ADDENDUM NO.: 3

DATE OF ADDENDUM: January 11, 2013

**SCSU New Academic Laboratory Building
Southern Connecticut State University, New Haven, CT
BI – RS – 283**

M6 TYPICAL FOUNDATION WALL PENETRATION AT COLD APPLIED WATERPROOFING
3" = 1'-0"

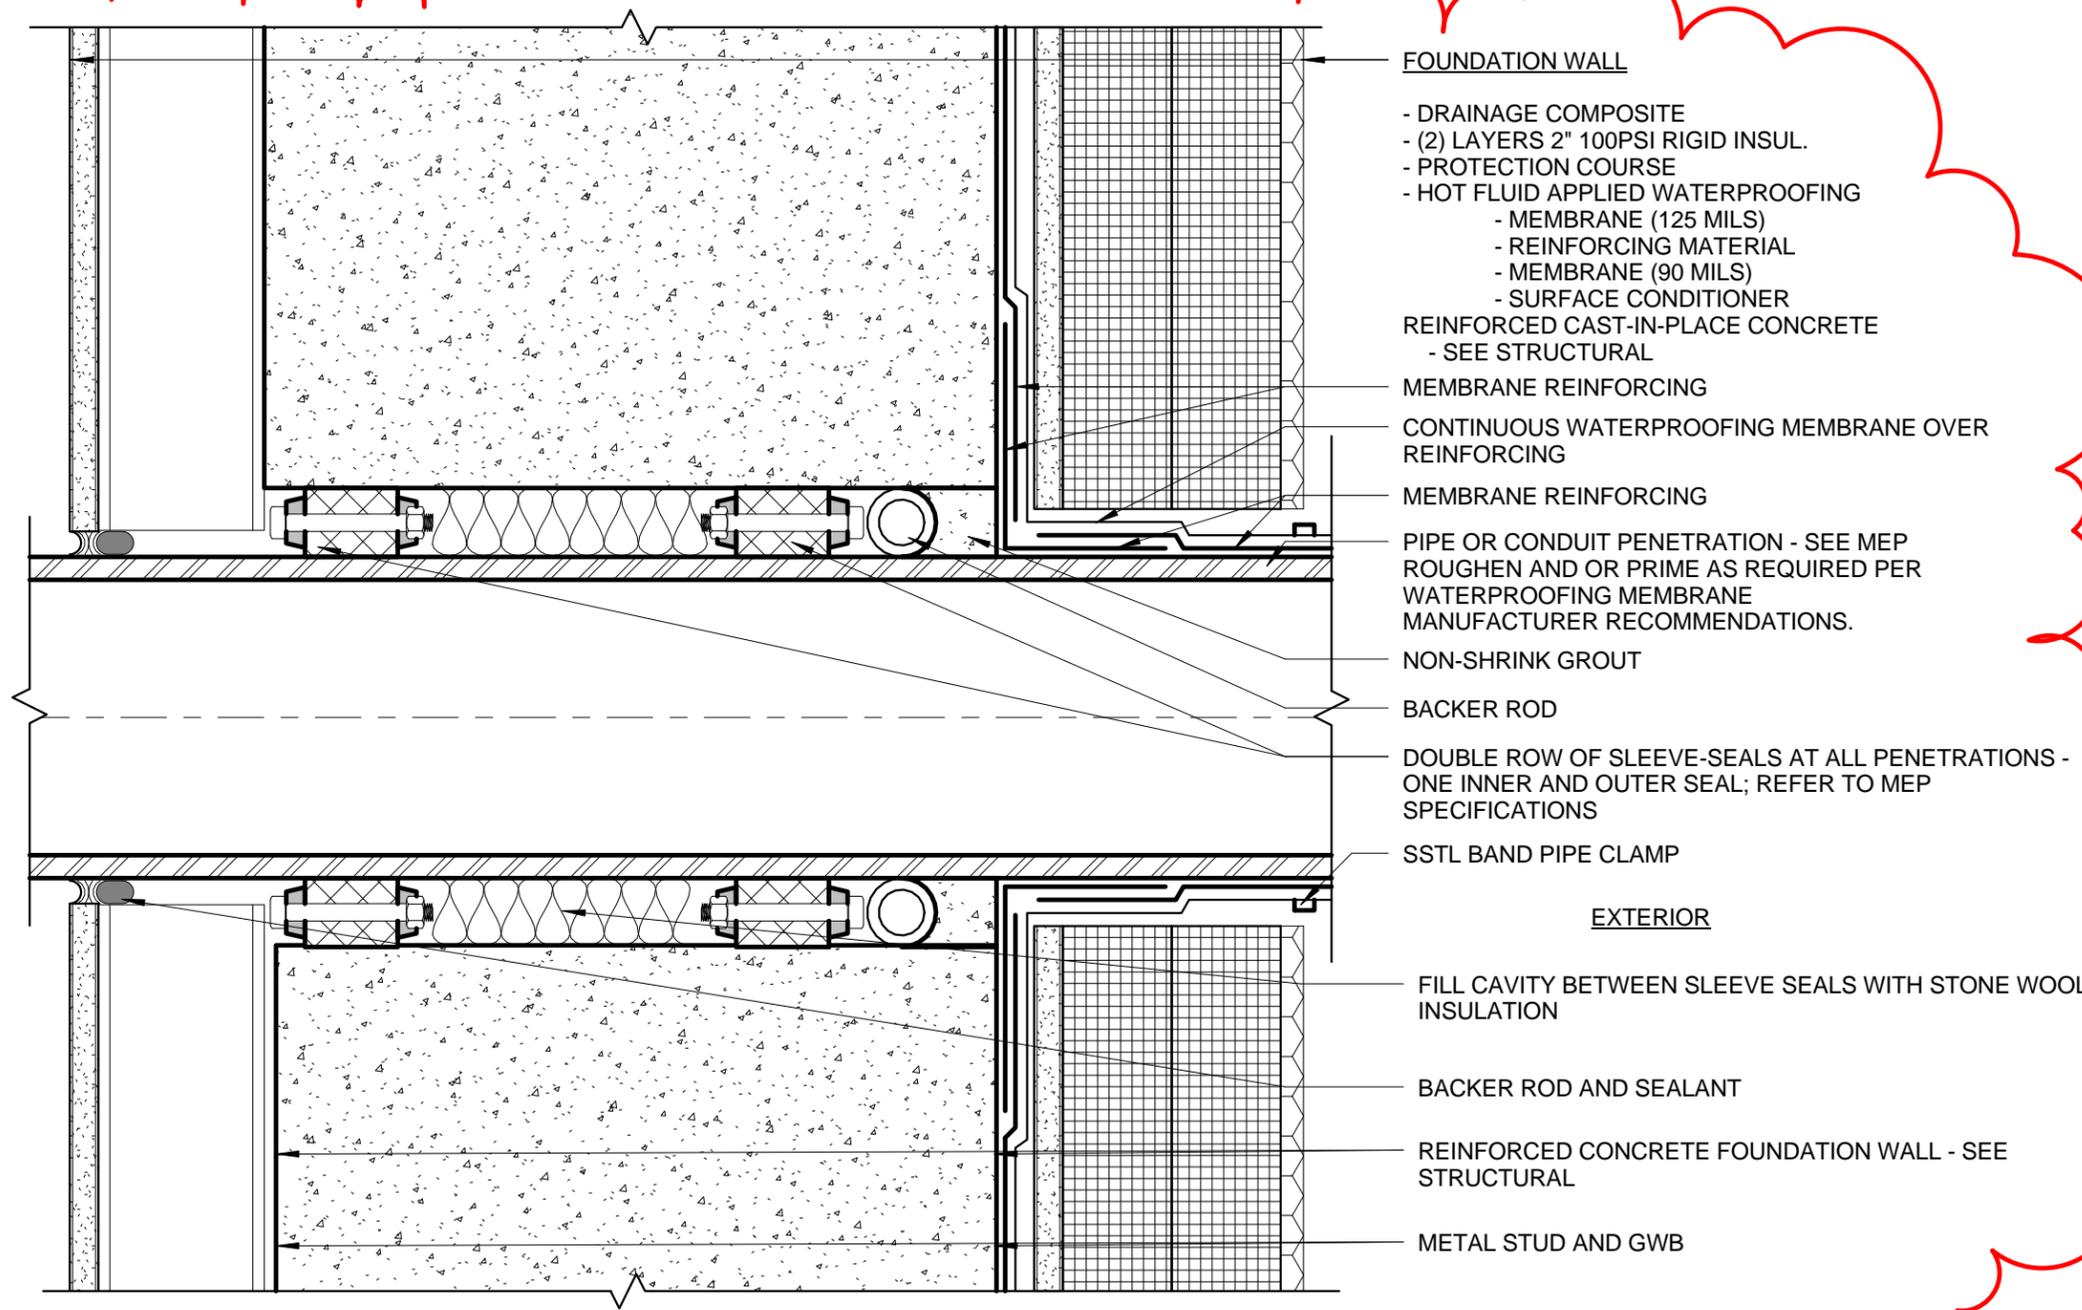
A206	K12/A206	Add Detail K12/A206 as drawn on attached SKA 6: RCP Pattern at Ceiling Type ACP-5
A512	M6/A512	Add Detail M6/A512 as drawn on attached SKA 1: Typical Foundation Wall Penetration at Cold Applied Waterproofing
A512	M6/A512	Add Detail J6/A512 as drawn on attached SKA 2: Typical Foundation Wall Penetration at Hot Applied Waterproofing
A520	D1/A520	Add Detail D1/A520 as drawn on attached SKA 3: Seismic Joint Plan Detail at Parapet - Typical
A531	L13/A531	Revise Detail L13/A531 as drawn on attached SKA 4: Plan Detail at Parapet and Metal Louver – South Entry. Clarification of parapet wall structure.
A531	M10/A531	Revise Detail M10/A531 as drawn on attached SKA 5: Plan Detail at Parapet and Louver Jamb. Clarification of parapet wall structure.
A601	L1/A601	Add note to the drawing: "Steel posts for stair by stair manufacturer - conceal in wall and bear on thickened slab."
Q401	18	Add note for metal lip at back of shelf. As shown on attached SKQ-1.

M10 PLAN DETAIL AT PARAPET AND LOUVER JAMB
1 1/2" = 1'-0"

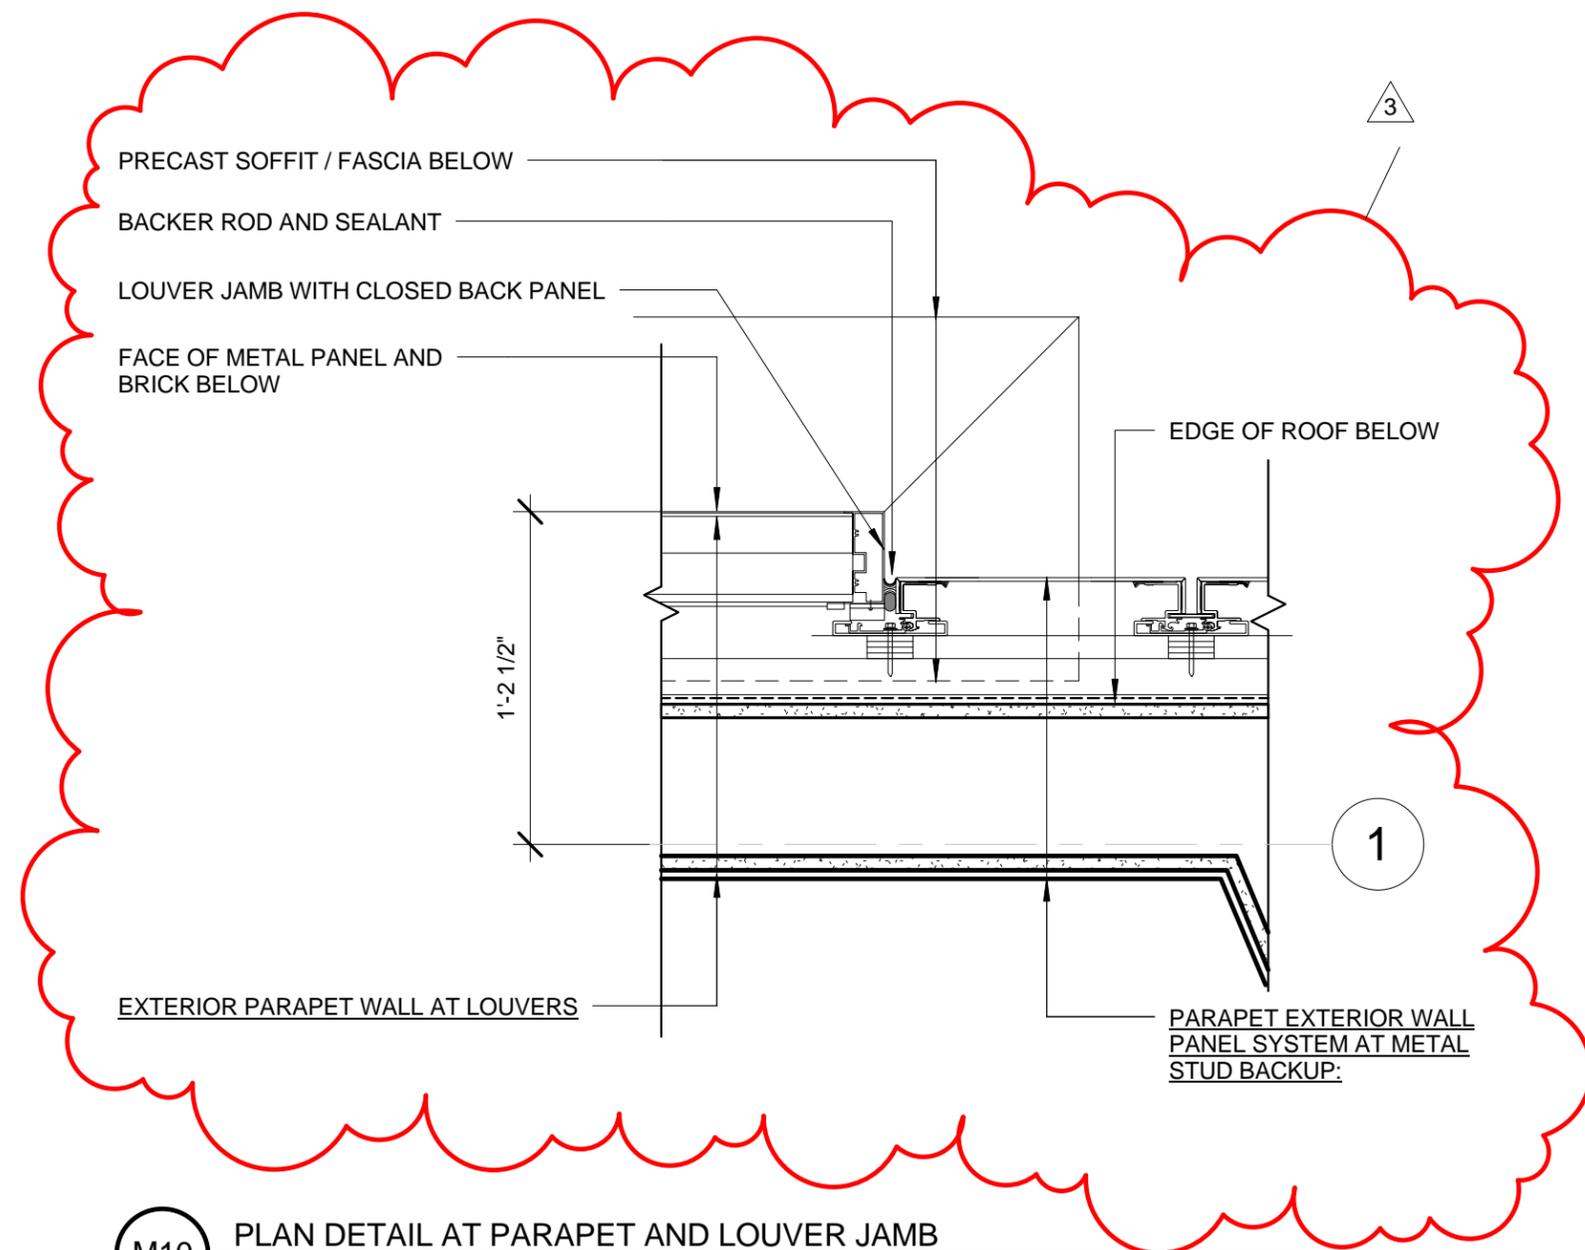
Response: Relieving angle is still present and extends down to support louver and precast. Detail will be revised to show particular condition at this location.

18 TYPICAL ADJUSTABLE SHELVES DETAIL NOT TO SCALE

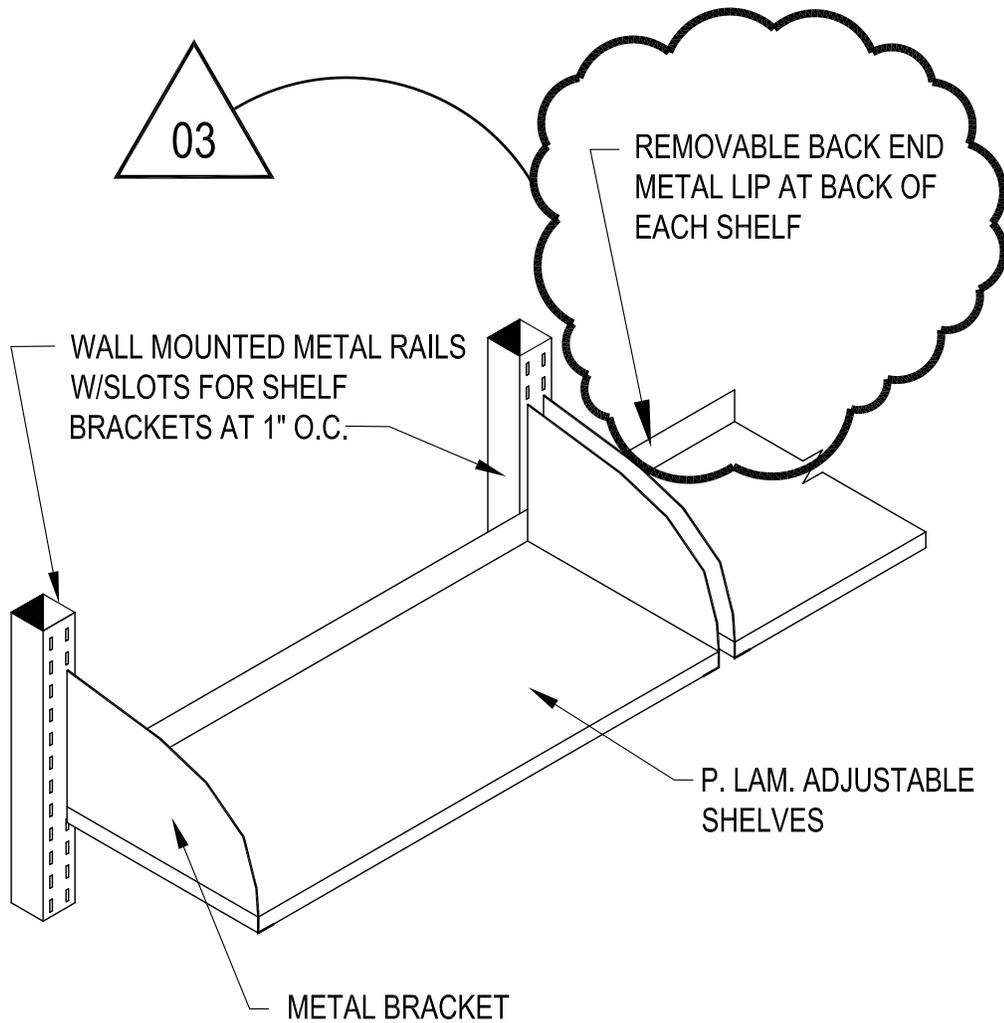
1. Per 123556 2.6 M 5, end lips are required at shelves. If shelves are provided per the details, the bookend brackets serve as end lips. Please clarify / confirm lip requirements

Response: Removable end lips are required at back of shelves as indicated in detail 18/Q401 and detail 9/Q402. Refer to detailed sketch to be provided in forthcoming addendum.

21 DETAIL OF ADJUSTABLE SHELVES AT ISLAND BENCH NOT TO SCALE

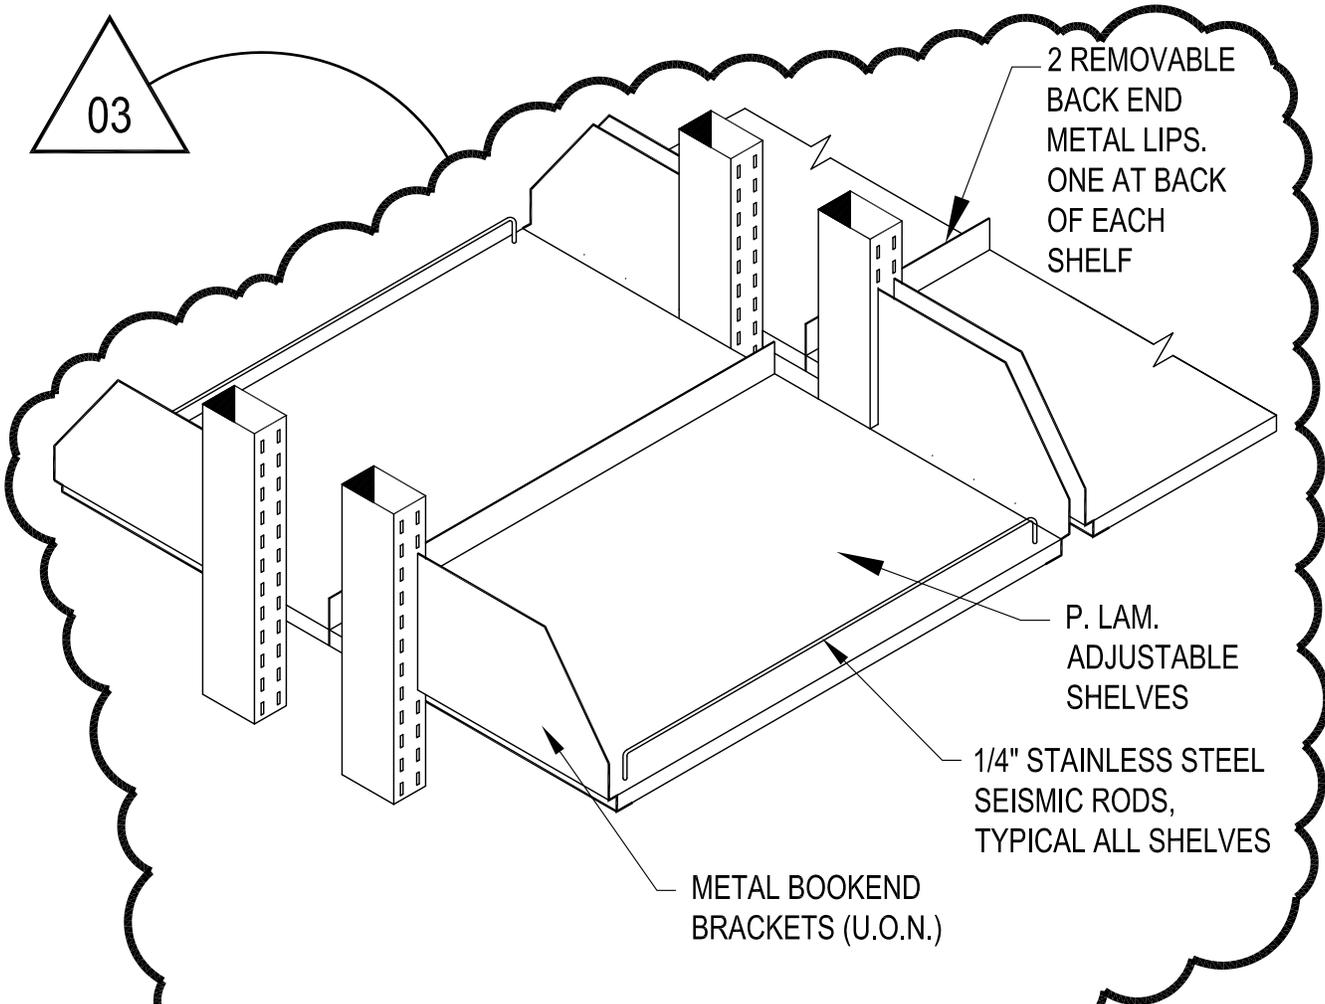
Q401	21	Add new detail of adjustable shelves at island bench. As shown on attached SKQ-2.
Q401	22	Add new detail of section through island bench. As shown on attached SKQ-3.
Q402	1/9	Add note for metal lip at back of shelf. As shown on attached SKQ-4.

1. Please clarify materials/construction of adjustable shelving support structure and shelving at island benches in Room 233A with polypropylene casework. Should the support structure and shelving here be polypropylene or are the typical painted steel supports and brackets with plastic laminate shelving acceptable?

Response: All casework and components including, but not limited to, adjustable shelving support structure and shelving at island benches are Polypropylene in Room 233A as indicated in construction documents. Use of metals are not acceptable.

DETAIL REF:
4H

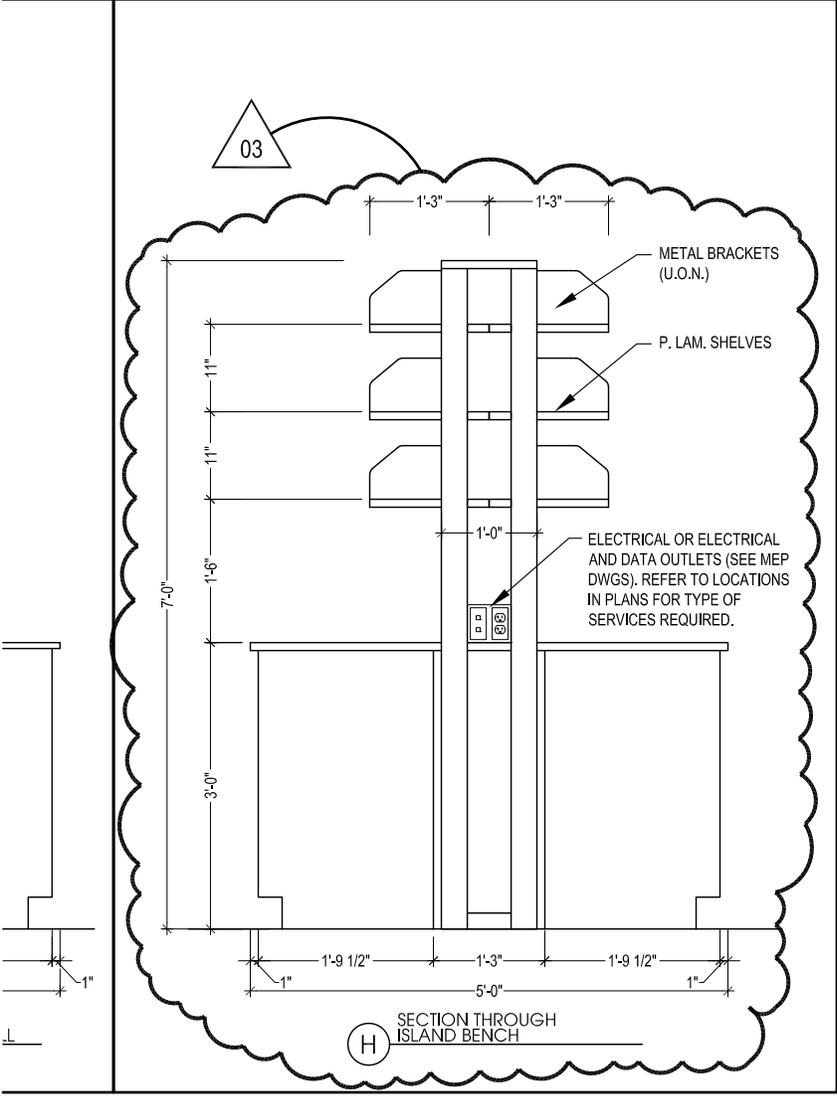
Q402	4H	Revise detail to indicate shelf uprights to be floor mounted. As shown on attached SKQ-5.
------	----	---

1. Per spec section 123556 2.6 M 4, top shelf is to fit flush with top panel at core. This conflicts with the detail referenced above and typical elevations which show the top shelf mounted below the top panel, and with its own inner shelf. Please clarify which method is preferred.

Response: Top shelf shall be mounted below the top panel as indicated in detail 4H/Q402. Inner shelves shall not be used. Each Shelf shall extend at back to cover half the distance of the upright width. Provide removable end lips at back of shelves. Refer to modified spec section 123556.2.6.M.4 and detailed sketch to be provided in forthcoming addendum.
